ACP-2021-078

**Enabling Remotely Piloted Aircraft Operations
from RAF Fairford - HALE**

Stage 5A – Technical Amendment Request

Figure 3 – Proposed Amendment of EGD218 C & D (Upper Altitude to FL660)

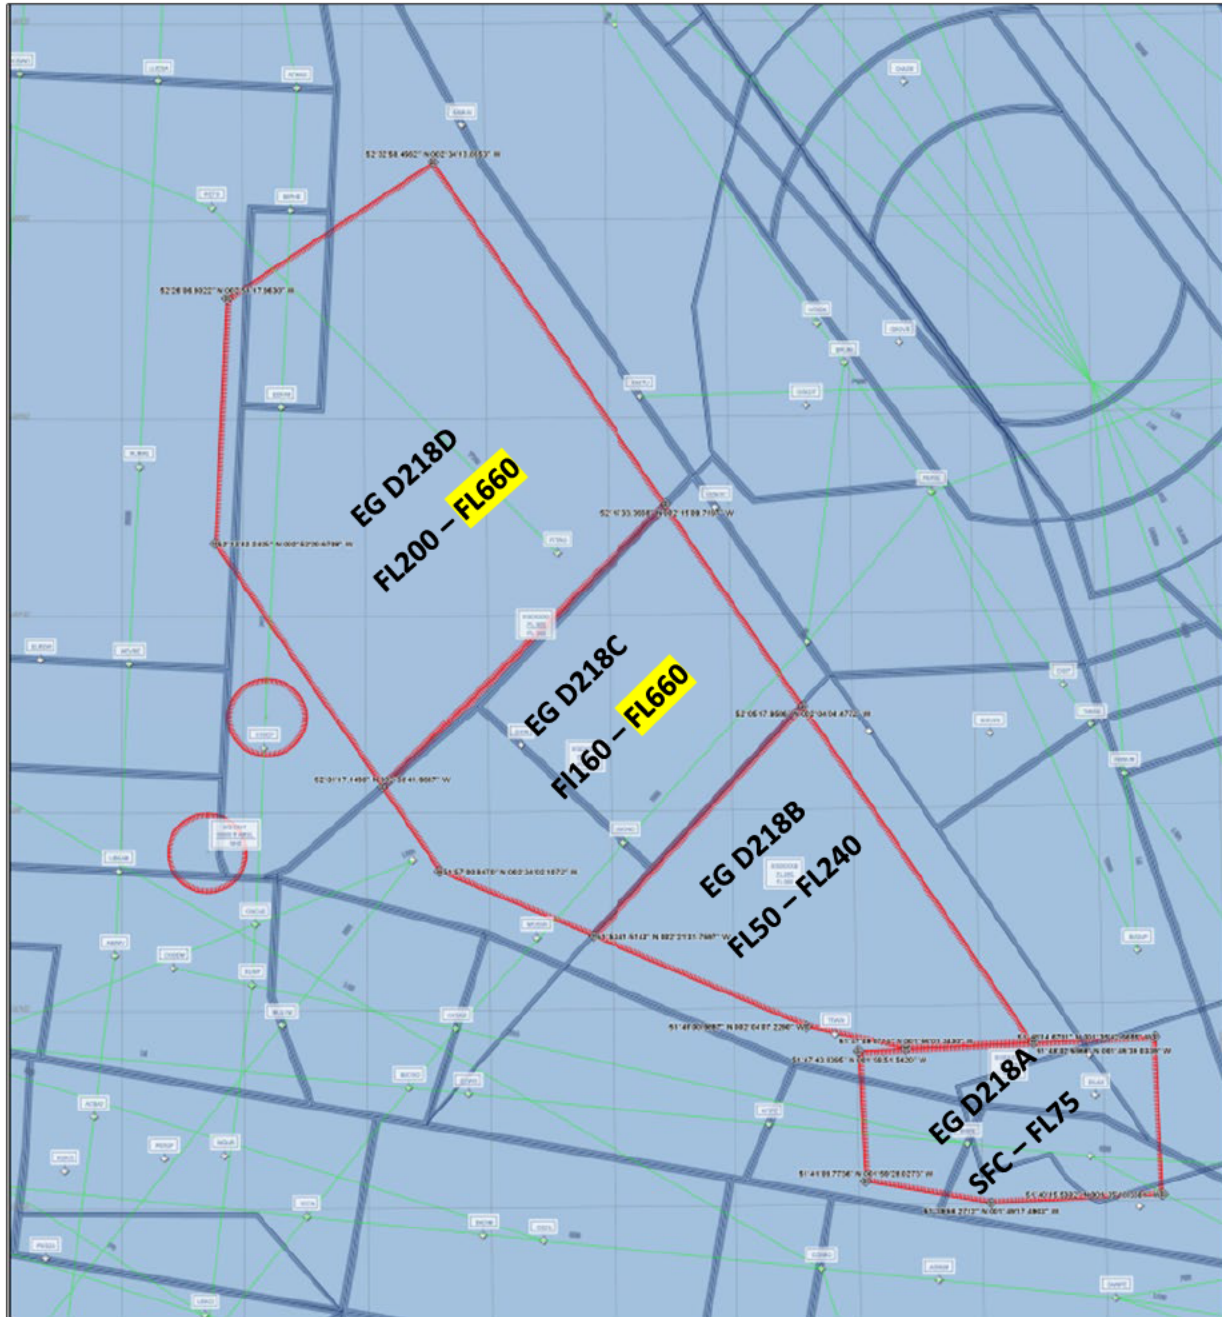
The proposed technical amendment would only change the upper limits of segments C and D from FL500 to FL660. There are no other amendments being sought to the altitudes of other segments and there would be no change to the proposed activation times, frequency, or duration of activation. This amendment is solely for regulatory compliance and future-proofing of the danger area complex.

They also shared that the description of “future proofing” was not aligned with the intent of the CAA’s AMS and that it effectively implements a barrier to High Altitude Operations. Further, NATS explained that they would consider objecting to the proposal if future-proofing was meant to be a “just in case” option as this would not fit with the principle of the FUA policy.

NATS also cautioned that while current usage may indicate that there would be no impacts to raising the upper level of the airspace, the Sponsor did not appear to consider future civilian traffic that will operate from FL500 – FL660.

Although we are more frequently seeing CAT operating at FL470 – FL510, it is easy to think that, based on current airspace usage, there isn’t any impact by raising the Upper Level of the DAs to FL660. This proposal does not appear to consider future High Level Ops of “new entrant” traffic which will operate at these extremely high altitudes, potentially for long periods of times in some cases. Therefore, the proposal described as “future proofing” is not aligned with the intent of the CAA’s AMS effectively implementing a barrier to High Altitude Operations that industry says are nearer to reality than is, perhaps, the current perception. You could read “future proofing” as “just in case” and this does not fit with the principle of FUA Policy and in this regard, we would need to consider objecting to the proposal.

Despite the increasing upper limit of EGD218C and EGD218D, the Sponsor does not expect any difference in the duration of activation prior to releasing the airspace as the flight profile is not anticipated to change. The aircraft was always expected to climb to a transit altitude above FL500 but as explained in section 1, the Sponsor worked under the assumption that segregated airspace would not be required above FL500. Because of this, the estimated duration of when the airspace would be able to be returned is not expected to change.

The Sponsor feels that the idea of “future-proofing” this ACP is in line with the principle of FUA and the Airspace Modernization Strategy. One of the objectives listed in the Airspace Modernization Strategy is, “‘future-proofing’ new airspace designs today to enable emerging requirements for Free Route Airspace and trajectory-based operations, thus minimising the potential need later on for lengthy changes in airspace design.”² The Sponsor feels that this is equally relevant to emerging requirements for HALE RPA flight at higher levels. Incorporating this capability now will prevent the need for future lengthy airspace changes.

Future civilian traffic at higher levels has been considered. This amendment not only protects the HALE RPA operating above FL500. It also protects future civilian traffic that will eventually operate from FL500 to FL660 by ensuring there is adequate segregated airspace to provide a safe environment for all. It should also be noted that, in line with FUA principles, only the required altitudes will be booked based on the operational requirement for each flight. This will ensure that as much airspace as possible will remain available to other users of the airspace.

If it is determined that increasing the upper levels of EGD218C and EGD218D to FL660 to future-proof the airspace is not possible, the Sponsor requests that the upper limits be increased to at least FL600 to account for current HALE RPA capabilities.
